SUPPLEMENTAL INSTRUCTIONS		PROJECT NO.
NTMWD AIR RELEASE VALVE VAULT RELOCATION		HOE132C
Caruth Lakes Phase 7C		SHEET NO.
City of Rockwall, Texas		SI-01

**EXISTING AIR & VACUUM RELEASE VALVE**  
NOT TO SCALE

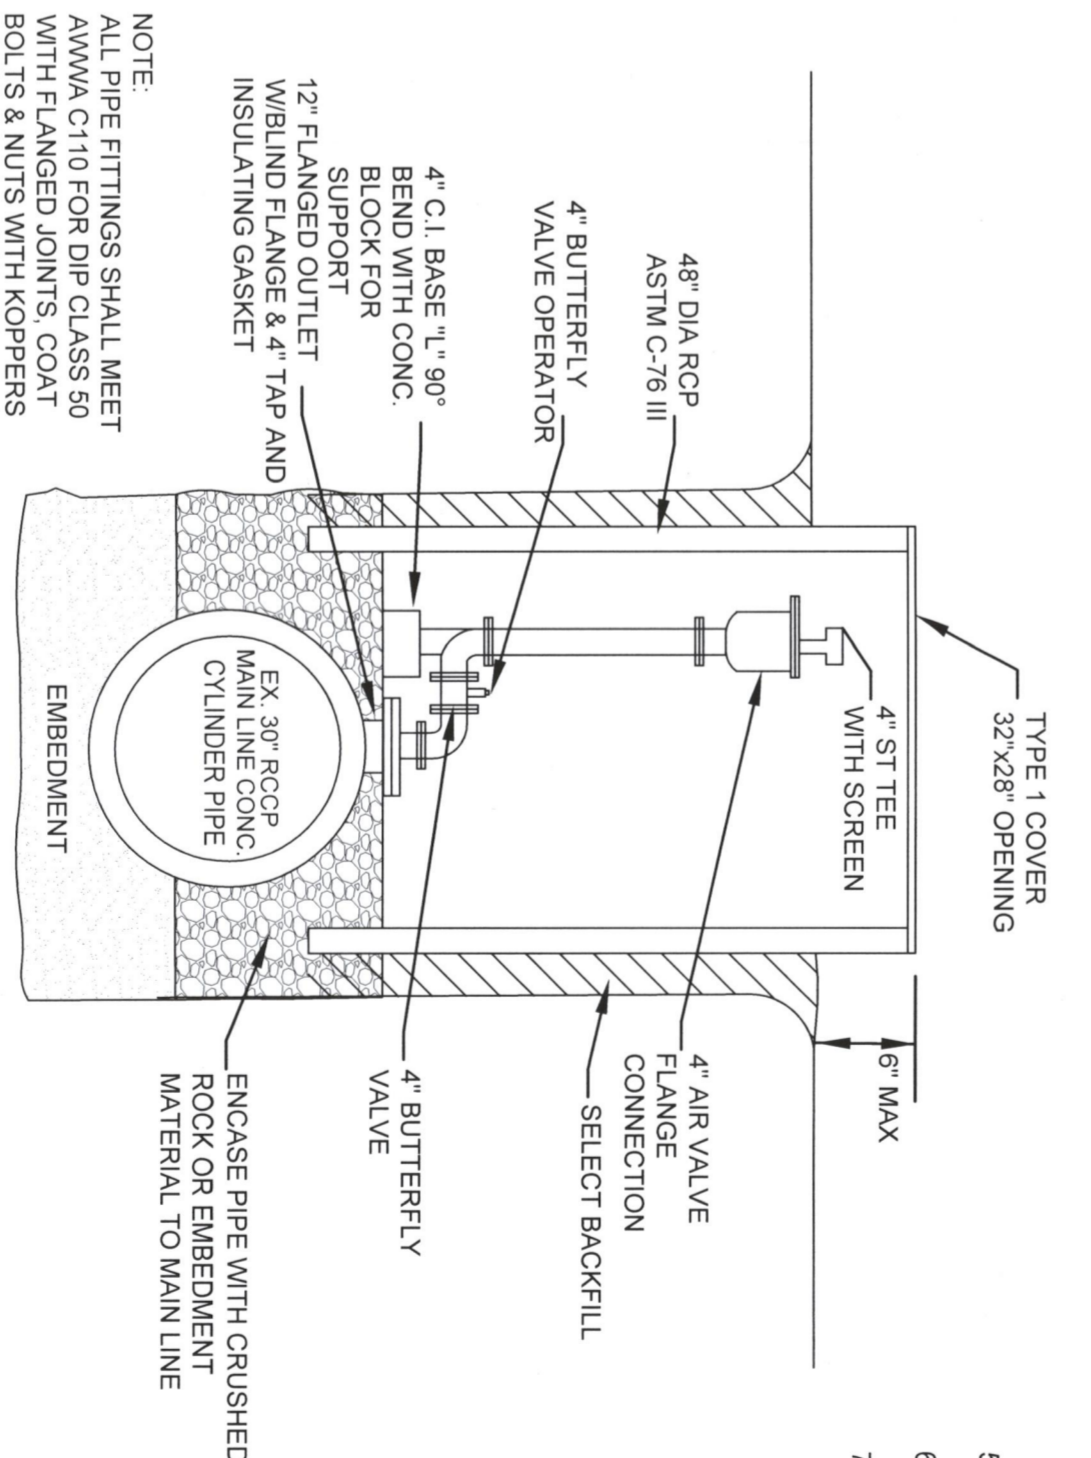
- NOTE:
1. REMOVE AND SALVAGE EXISTING BLOCK SUPPORT, MANHOLE RISER PIPE, LID AND COVER.
  2. RELOCATE OUTSIDE PROPOSED PAVEMENT TO GRASS AREA WITHIN THE NTMWD EASEMENT OUTSIDE OF THE CITY OF ROCKWALL, RIGHT-OF-WAY. SEE PLAN.
  3. REMOVE EX. 90° BEND AND RISER PIPE. SEE PROPOSED PROFILE FOR NEW CONFIGURATION.

**PROPOSED PROFILE AIR & VACUUM RELEASE VALVE**  
NOT TO SCALE
